TELEPHONE SET BASES—KIT PLAN

IDENTIFICATION, INSTALLATION, CONNECTIONS, AND MAINTENANCE

1.001 This addendum supplements Section 503-100-103, Issue 1.

1.002 This addendum is issued to add information on the current version of the 840200000 Universal Dial Number Plate.

Fig. 3.1—Universal Dial Number Plate,
Current Version

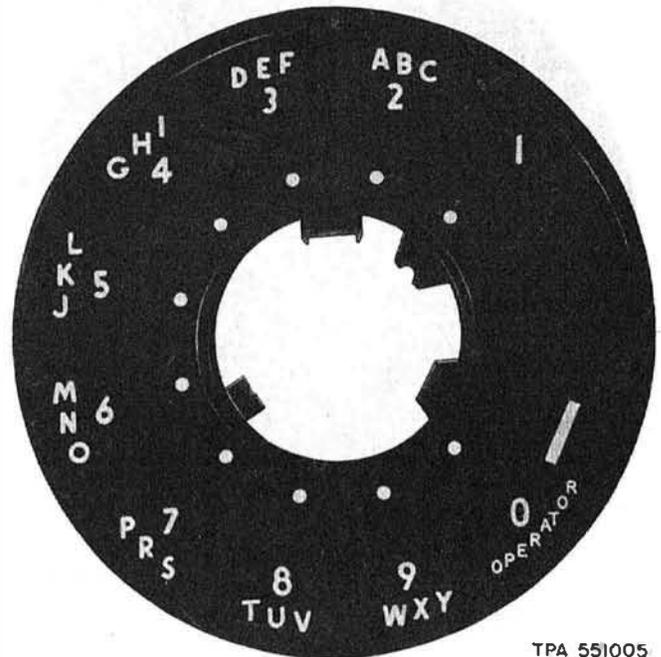
(2.1) Current production dial number plate requires no modification to be used with either the early version or current version of the 9-type dial (Fig. 3.1 and 3.2).

(3.1) Current production dial number plate requires no modification to be used with either the early version or current version of the 7-type dial (Fig. 3.1 and 3.3).
